Thanet Extension Offshore Wind Farm

Appendix 5 to Deadline 8 Submission: Applicant's
Response to Interested Parties Deadline 7
Submissions – Shipping and Navigation

Date June 2019

Table 1 Narrative on NE Spit Pilotage operations animation

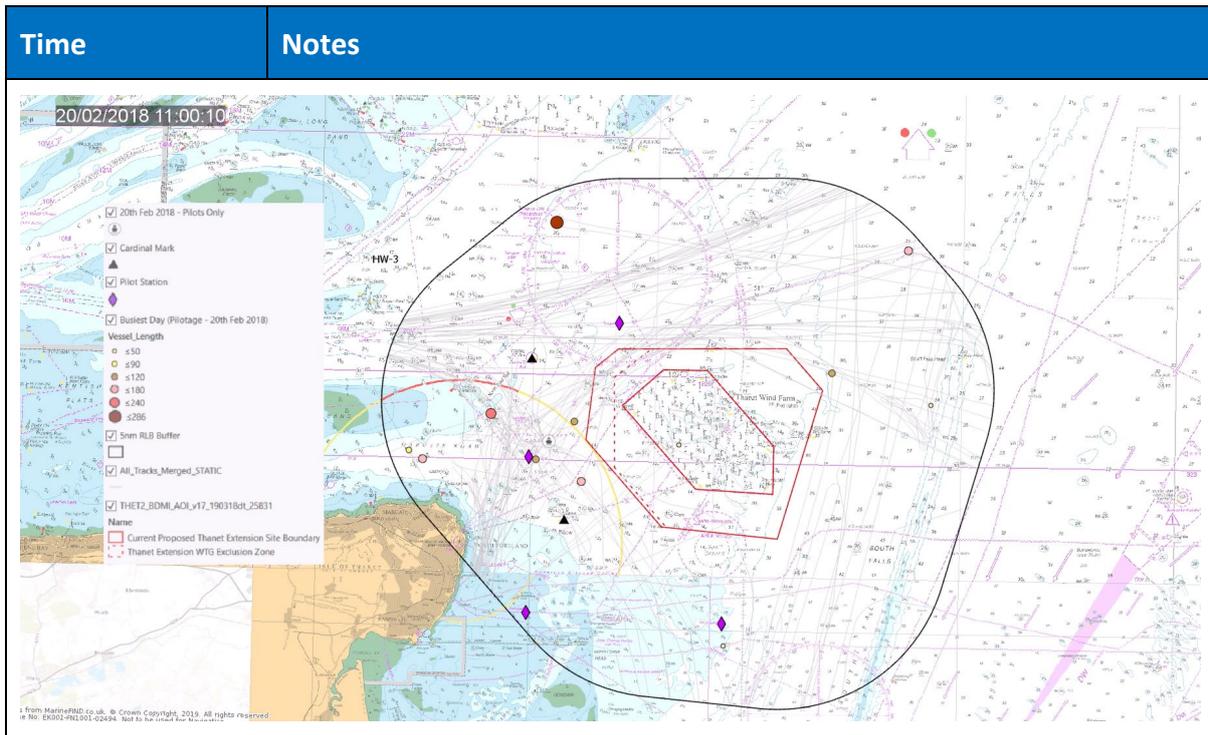
30 The POT/LG offer no response or feedback to the animations. the PLA/ESL contend at D7 that

32 Notwithstanding this the Applicant has generated a further animation drawing on the AIS data from the same 12 month period to identify the busiest day for pilotage vessel tracks (20th Feb 2018). It is hoped that in addressing ESL's criticism the Applicant also provides the ExA with relevant and useful contextual information in understanding the complexity of operations for the busiest days for all vessels, the busiest day for vessels over 90m in length, a 24 hours period during which ESL records show their operations to be at limit state, and the busiest day for pilotage operations specifically. It is the Applicant's view that the updated animation demonstrates that there are periods when numerous pilotage operations are undertaken in close proximity spatially and temporally. The Applicant notes however that when certain periods are looked at in detail the animations demonstrate that pilotage operations are managed to keep pilot transfer durations to a minimum, therefore concentrating activities around the NE Spit pilot diamond, rather than elsewhere. Table 1 provides a narrative description of notable occurrences during 24hr period noted as particularly busy for pilotage.

Time	Notes
0001 - 0830	4 single transfers occur during the middle and morning watch (0001 – 0800). 2 out bound vessels departing via the inshore channel to the South East and
